Section 42A Report

Report on submissions relating to Variation 2

**Foodstuffs (South Island) Properties Limited request to
rezone approximately 7.3 hectares of Medium Density
Residential Zone land at 157 Levi Road in Rolleston to a
Large Format Retail Zone**

28 February 2025

Figure 1 – Proposed PREC13 ODP overlaid with the consented PAK'nSAVE and adjoining MRZ ODPs (Source: Transport evidence of Mr. Andy Carr, Figure 2, Appendix 6).

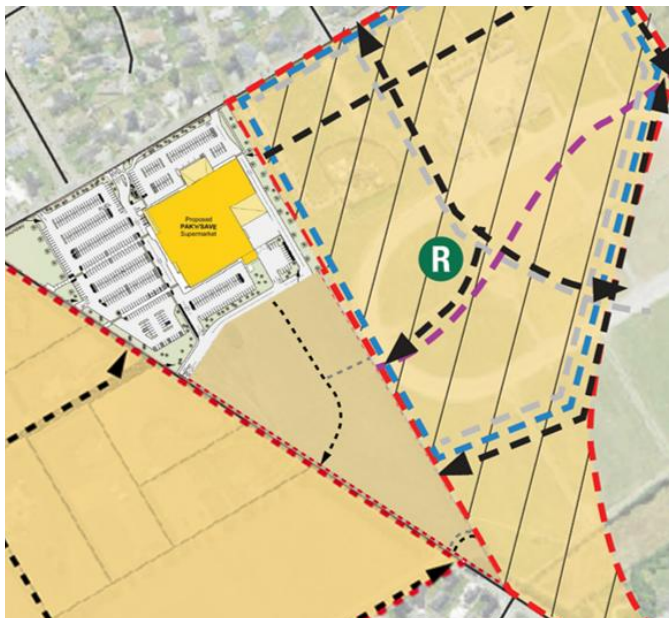
- a. The 5m landscape strip along the Lincoln Rolleston Road boundary, including specimen trees at a minimum 5m spacing needs to be established, which shall include a return along the northern edge of the future proposed Primary Road connection off Broadlands Drive. Mr. Ross identifies that this amendment will maintain consistency with the consented RC216106 planting scheme and provide certainty that the landscape mitigation strategy contained in Variation 2 will be achieved.⁴⁶

- b. Require one tree per five parking spaces within the parking area and add maximum spacings of one tree per three spaces and tree species of medium or high grade heights. Mr. Ross considers that a higher level of certainty is required as this landscape mitigation will have the most benefit in mitigating adverse visual effects from those viewing the site from Lincoln Rolleston Road, particularly the southern portion where the built form is likely to be closest to the road boundary.⁴⁸

- c. Apply a 20m minimum building setback to the Lincoln Rolleston Road boundary. Mr. Ross considers that this extended minimum building setback is required to maintain sufficient distance for the proposed mitigation planting to filter views and reduce the visual dominance of the future commercial buildings that would be enabled by the Variation 2 provisions.⁵⁰

- e. Require that a landscape management plan is submitted for SDC's approval at the time any future resource consents are sought, which covers security, maintenance, and pest and weed control within the proposed northeastern 10-metre-wide biodiversity strip.⁵⁴

- f. Provide a future pedestrian and cycle connection to the MRZ to the north-east and the related eastern connection illustrated on the development area DEV-RO12 ODP. Mr. Ross considers that this is required to achieve greater permeability consistent with the adjacent connections illustrated in the development area DEV-RO12 ODP, to control public access through the proposed north-eastern boundary biodiversity strip, and to appropriately integrate Crime Prevention Through Environmental Design (CPTED) into the ODP.

- g. Require denser screen planting that can reach a minimum of 3m in height in addition to the specimen trees at minimum 5m spacings adjacent to the outdoor storage areas illustrated on the concept plans. This additional planting is also required to screen the storage area that is adjacent to the proposed future primary road connection off the extension of Broadlands Drive. Mr. Ross considers that this higher density planting is required to effectively screen the potential adverse visual effects arising from the built form that would be enabled by Variation 2.⁵⁷

I recommend the proponent addresses this through amendments to the proposed PREC13 ODP plan and any associated narrative (refer to the suggested wording in **Appendix 1**). I consider there is sufficient scope provided for this amendment through the relief sought in submissions.⁴⁷

I recommend the proponent addresses this through amendments to the proposed PREC13 ODP plan and any associated narrative (refer to the suggested wording in **Appendix 1**). I consider there is sufficient scope provided for this amendment through the relief sought in submissions.⁴⁹

I recommend that this is addressed through an additional qualifier in the proposed PREC13 ODP plan and any associated narrative (refer to the suggested wording in **Appendix 1**). I consider there is sufficient scope provided for this amendment through the relief sought in submissions.⁵⁵

In advance of this additional evidence, I recommend the proponent addresses this through amendments to the proposed PREC13 ODP plan and any associated narrative (refer to the suggested wording in **Appendix 1**). I consider there is sufficient scope provided for this amendment through the relief sought in submissions.⁵⁶

I recommend the proponent addresses this through amendments to the proposed PREC13 ODP plan and any associated narrative (refer to the suggested wording in **Appendix 1**). I consider there is sufficient scope provided for these amendments through the relief sought in submissions.⁵⁸
